IMPERIAL PARK 132kV GIS SUBSTATION

LANDSCAPE AND VISUAL APPRAISAL RESPONSE TO LPA COMMENTS

Prepared for SSE Energy Solutions
November 2025

APPLICATION NUMBER: RECON 25/0520

Image 2-1: Extract of the Site Context Plan.

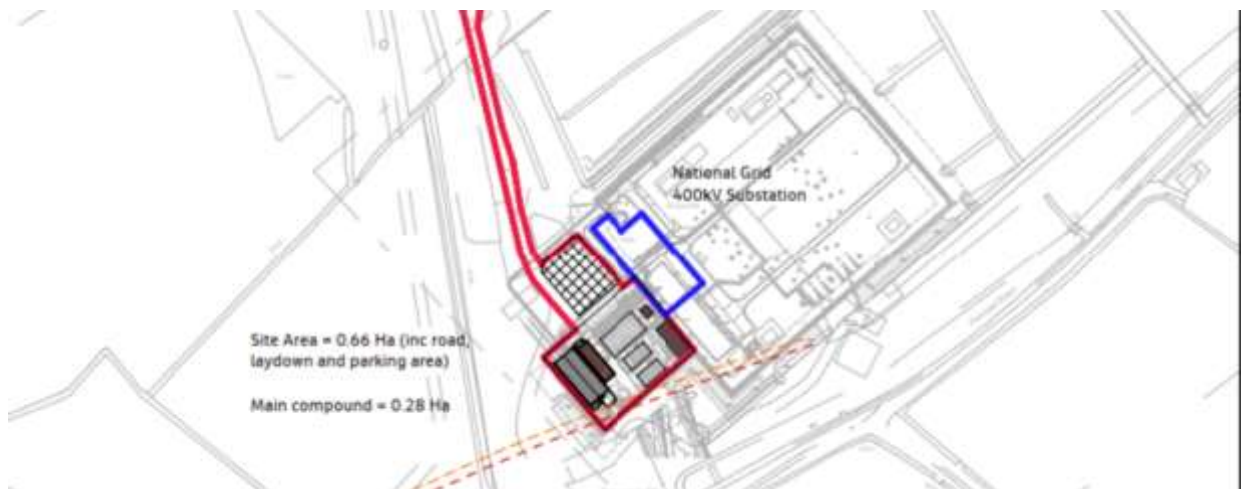
2. The future management of existing tree groups as mitigation should be included where this falls within the blue line boundary.

- 2.6 With reference to the following extract of the Site Location Plan, the blue line covers land to the north-east of the Site, prior to the National Grid 400kV Substation. There is no vegetation within this blue line.
-

Image 2-2: Extract of the RPS Tree Survey illustrating existing tree groups.

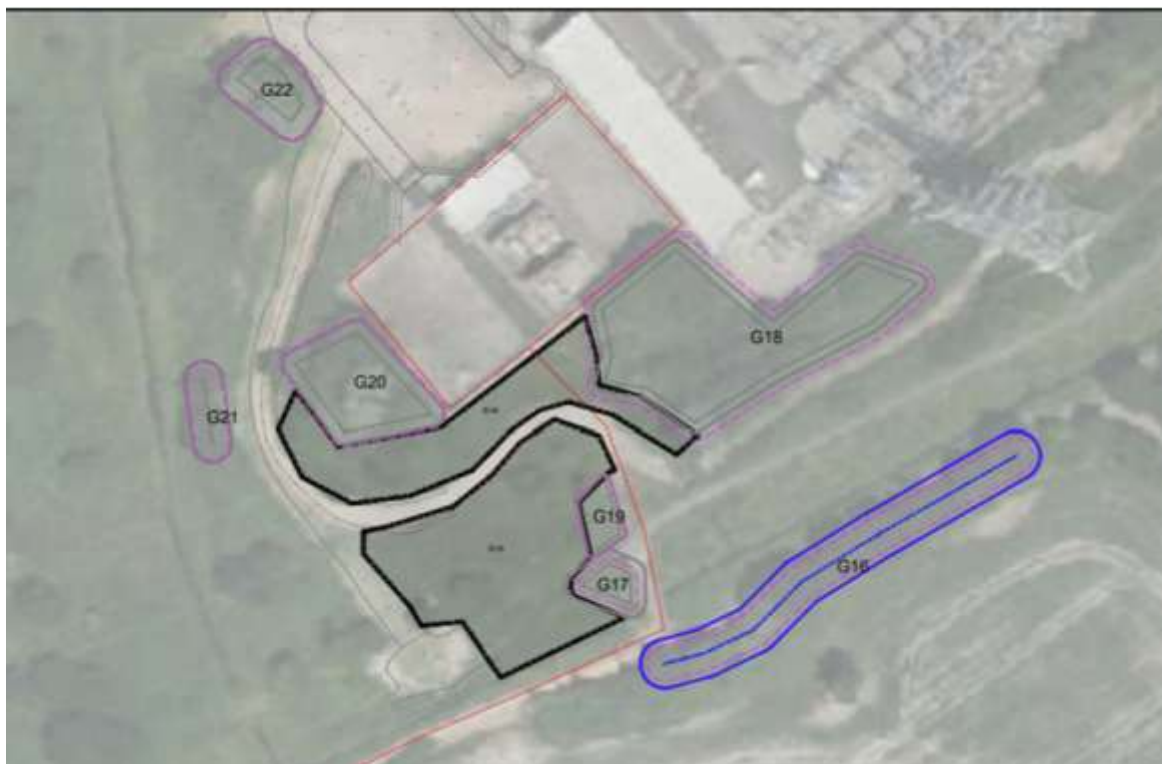
There is no commentary on the future management of tree groups shown in the Tree Survey extract below and how this would contribute to visual amenity mitigation.

- 2.7 However, with reference to the following extract of the RPS Tree Survey, there is vegetation to the south of the Site, extending to the southern edge of the Green Lane.

- 2.8 This vegetation is understood to be within land owned by Newport City Council (NCC). The Applicant is prepared to enter into a Section 106 agreement with NCC to facilitate the management of these tree groups identified in the Tree Survey between the Site and the Green Lane.
-

-
- 2.9 The management would be based upon ensuring continued vegetation and tree coverage within these areas for visual screening and functional value, along with enabling the future succession of young trees to grow taller in height.
- 2.10 Whilst this area is within the constraints of the pylon line and swing zones of the pylon wires, given there is existing vegetation present, it is considered that by ensuring its retention and increasing its overall height, in time, this would reduce views from the immediate south of the Site, along the Percoed Reen and Green Lane.
- 2.11 The mechanism for the management would be via a combination of yearly inspections and management guidance for contractors, controlled by a Vegetation Management Plan (VMP). The VMP could be conditioned as part of the planning approval.

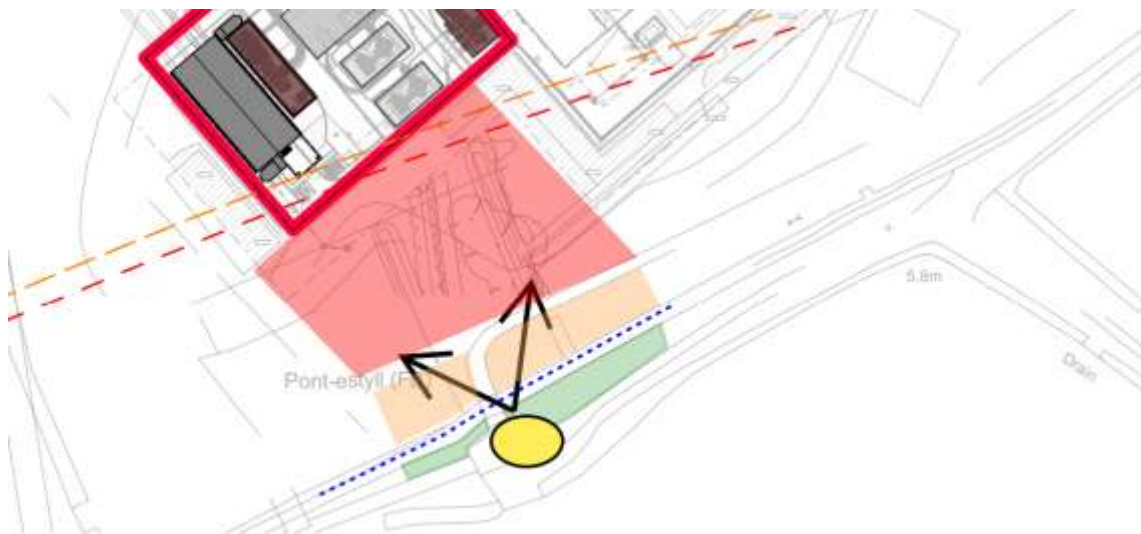
3. Any opportunities for planting within a blue line boundary (outside the constraints) should be identified.

- 2.12 With reference to the following sketch, the intervening land between the Green Lane and the Percoed Reen cycleway has been reviewed in respect of potential additional planting in respect of views from the Green Lane (illustrated by the yellow dot),

- 2.13 As noted above, with the red hatch and yellow hatch areas under the pylons and within the swing safety zones, it is proposed to undertake the management of these areas via a Section 106 agreement, with NCC (as the landowner for the coloured areas), rather than implement new planting.
- 2.14 A new low height/scrub planting is proposed in the green hatch, adjacent to Green Lane. Whilst it would enclose the path once established, it would reduce the visibility of the proposed building from along the lane. The operational constraints of the swing-zone would require the vegetation to be managed at around 2m in height. The proposed species would mirror those in the surrounding landscape, e.g. *Rosa canina*, *Salix fragilis*, *Salix caprea*, *Crataegus monogyna* and *Alnus glutinosa*.
-

-
- 2.15 The landscape management of this new planting would be covered by the VMS and the planting plan could form part of the landscape conditions.
- 2.16 In summary, it is considered that with the proposed management and new planting in land to the south of the Site, the visual effects from the Green Lane (Viewpoint 13) can be mitigated. The new planting and management of the existing vegetation would be delivered by the Applicant entering into a Section 106 agreement with Newport City Council. The details of this and the proposed planting and management can be covered by conditions, if found to be acceptable by Landscape Officers.
-
